A6.1

A6.2

A6.3

1 Wall Section 2/B - Callout 3

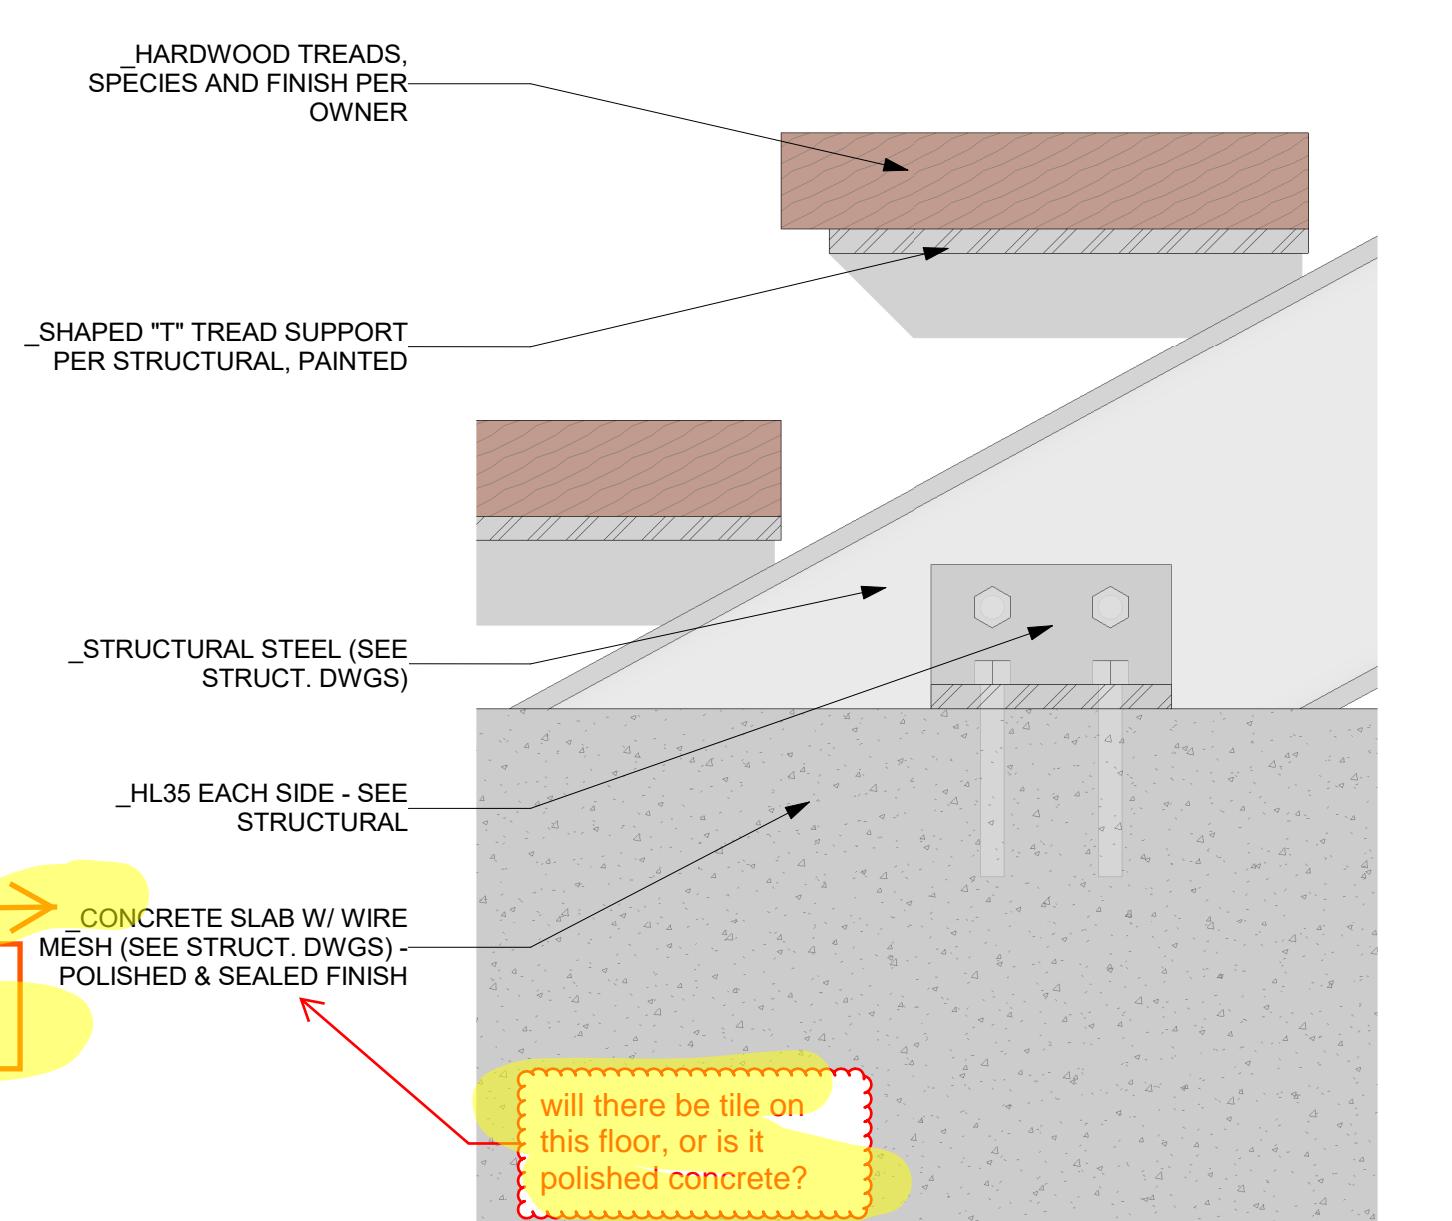
in general, do you use a vapor barrier in Laguna Beach? or is it one of those magical goldilocks zones, that doesn't require one? :)

Do you mean the vapor barrier under the slab? so, yes, we need the vapor barrier. Here's what the engineer specifies:

4 Wall Section 2/B - Callout 4

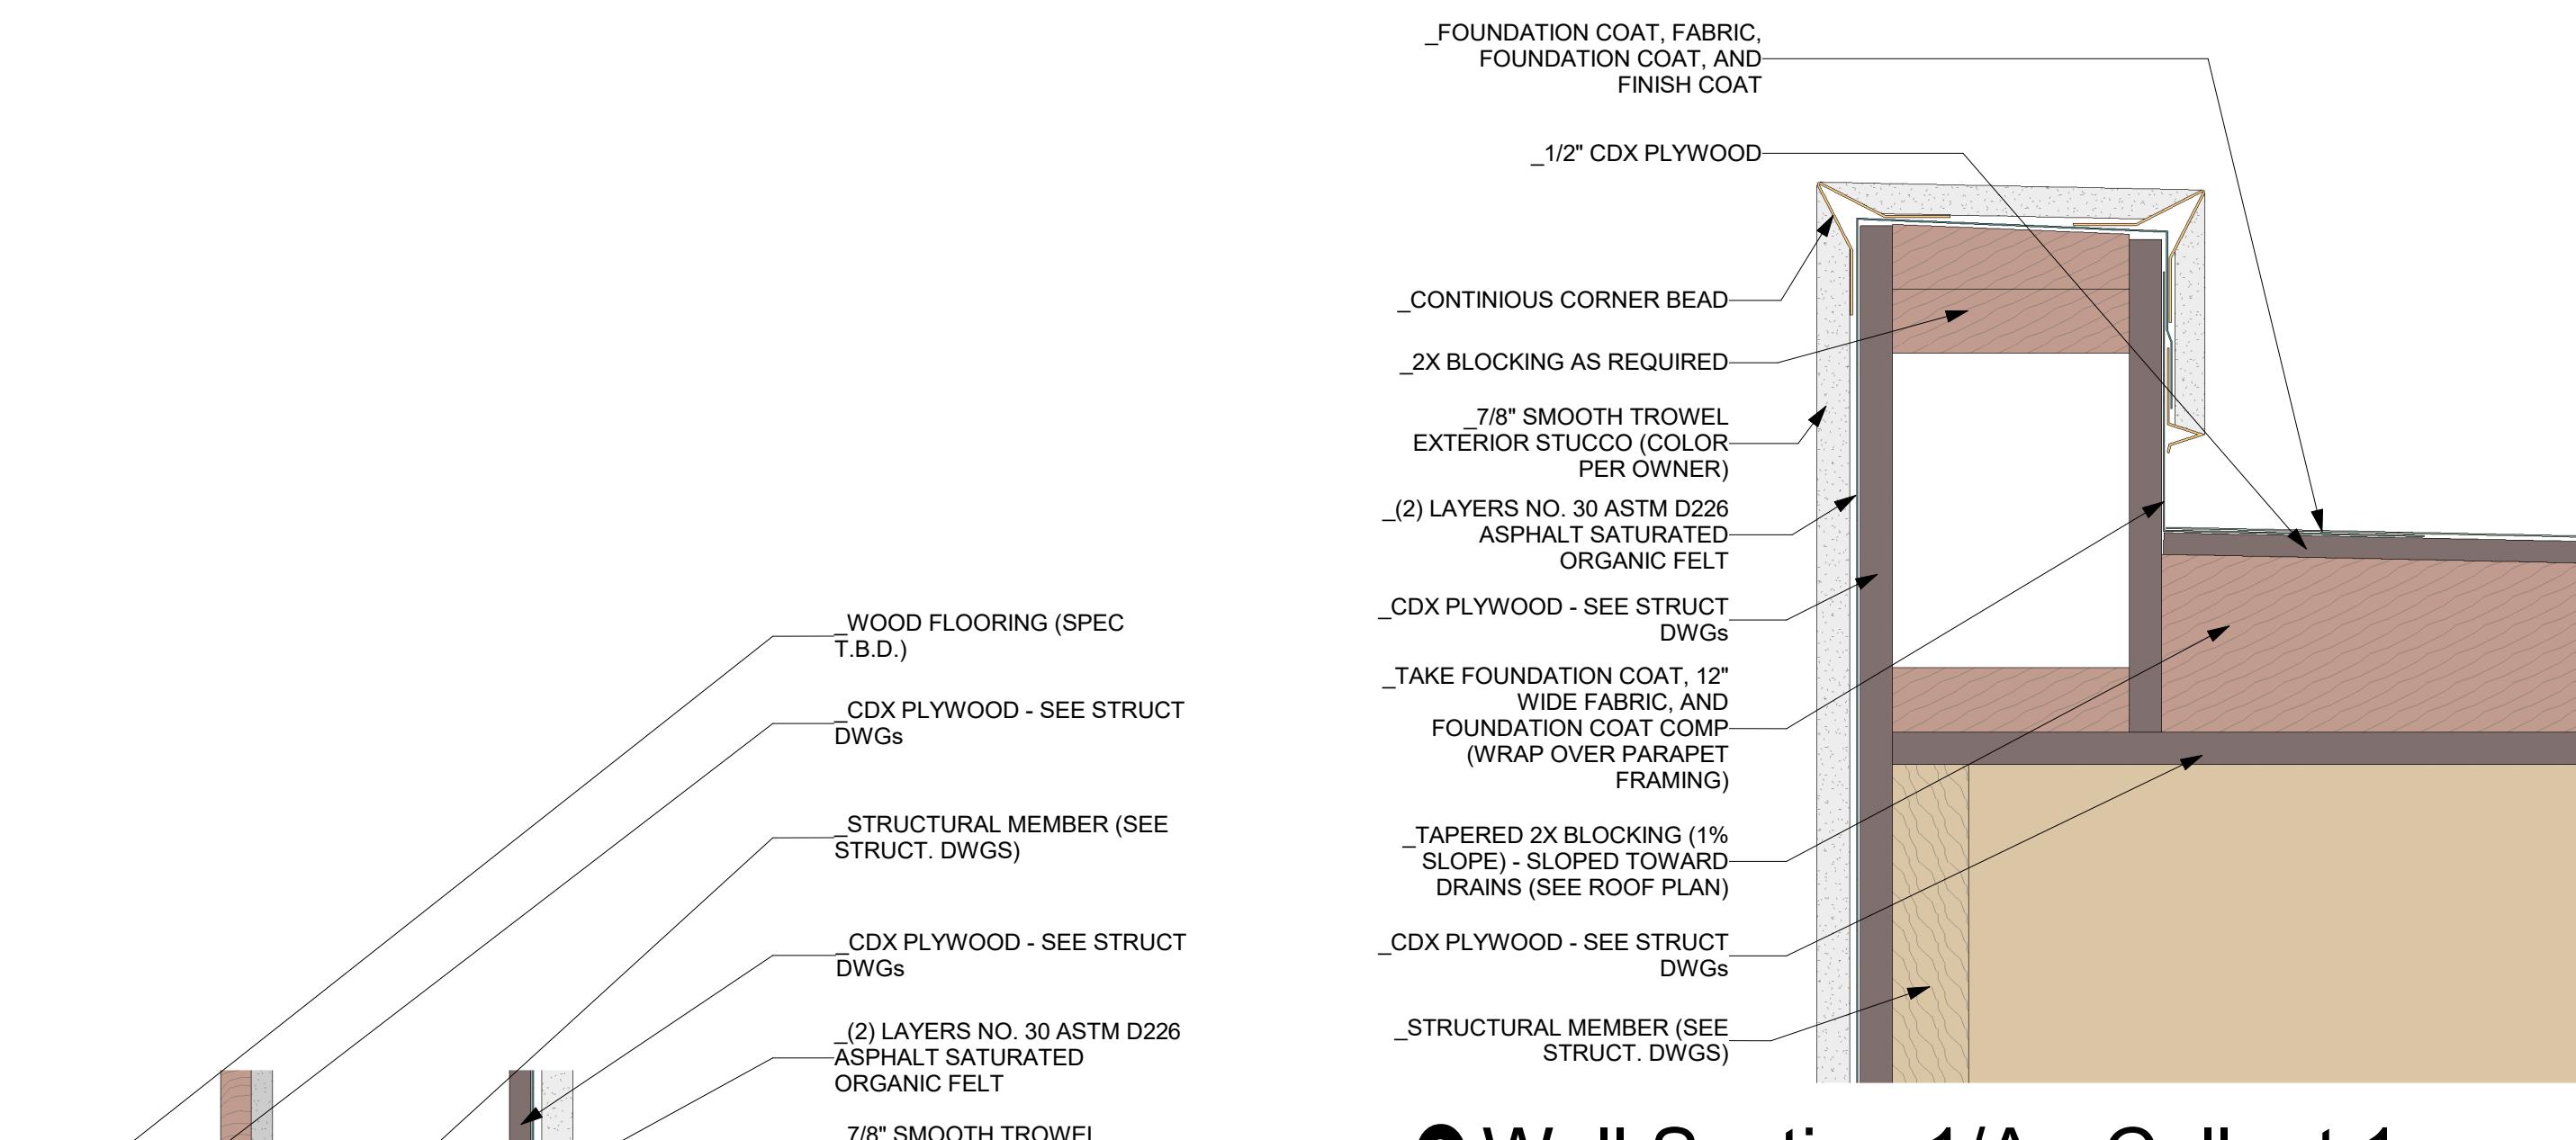
will there be tile on this floor, or is it polished concrete?

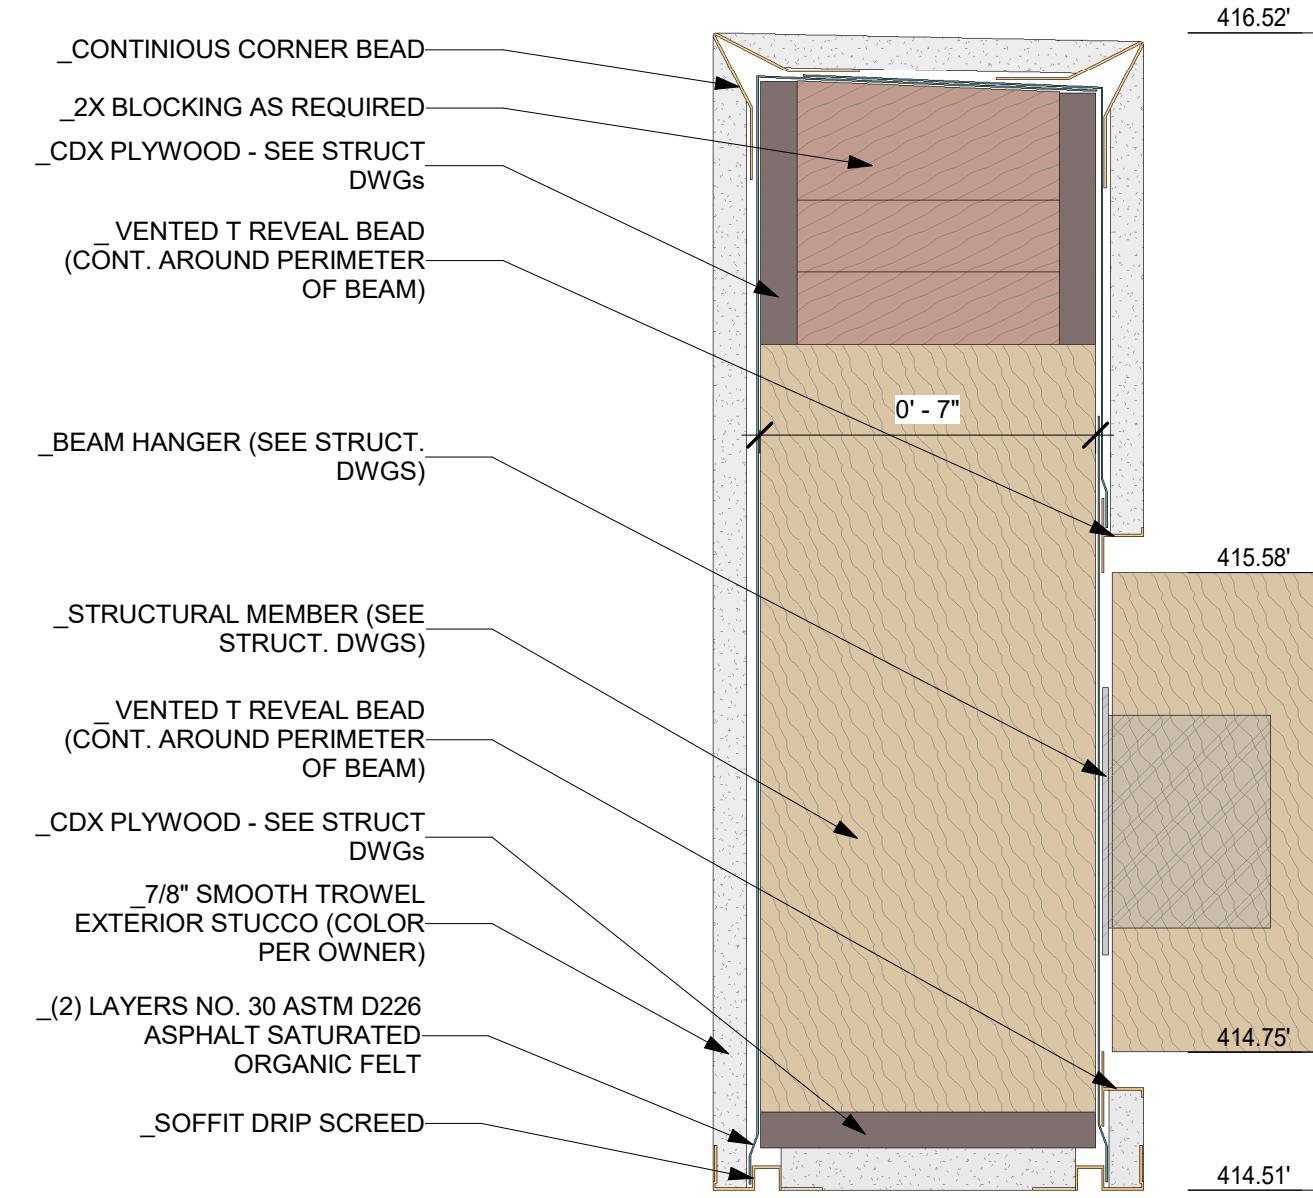
please add that
note - or refer to
this section of the
code in the detail
notes.

R903.4.1 Secondary (emergency overflow) drains or scuppers

Where roof drains are required, secondary emergency overflow roof drains or scuppers shall be provided where the roof perimeter construction extends above the roof in such a manner that water will be entrapped if the primary drains allow buildup for any reason. Overflow drains having the same size as the roof drains shall be installed with the inlet flow line located 2 inches (51 mm) above the low point of the roof, or overflow scuppers having three times the size of the roof drains and having a minimum opening height of 4 inches (102 mm) shall be installed in the adjacent parapet walls with the inlet flow located 2 inches (51 mm) above the low point of the roof served. The installation and sizing of overflow drains, leaders and conductors shall comply with the California Plumbing Code.

2 Wall Section 1/B - Callout 4
3" = 1'-0"

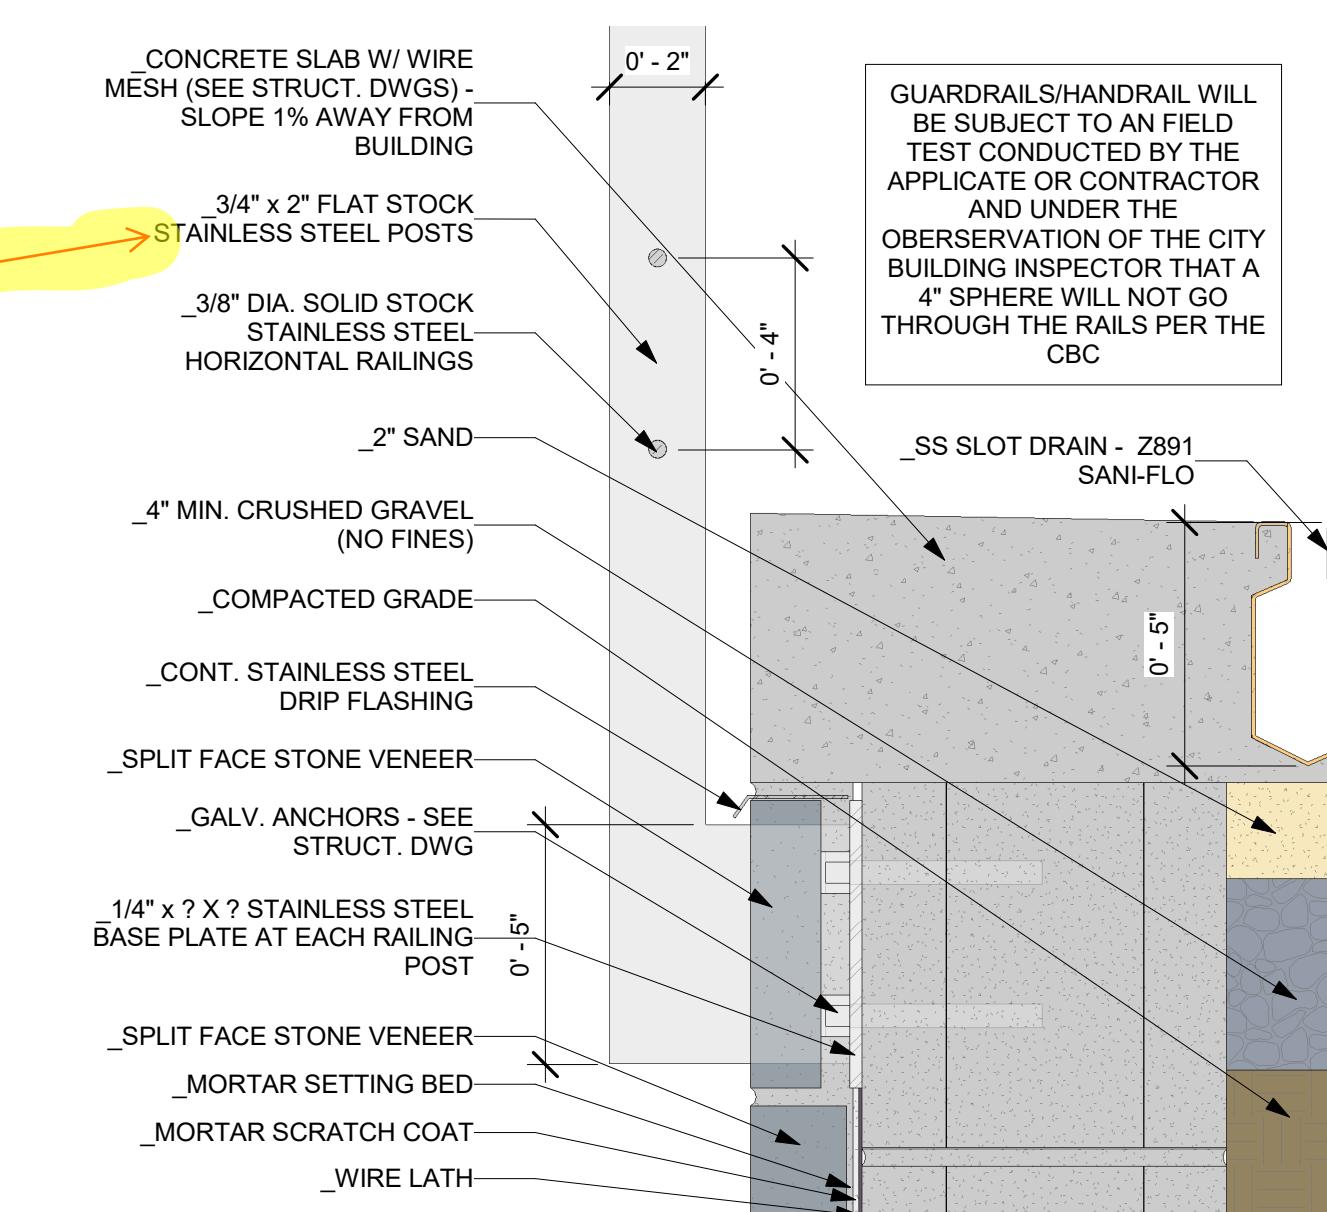
metalized, primed
and painted.. color
per architect
painted steel?
Galv?
SS?
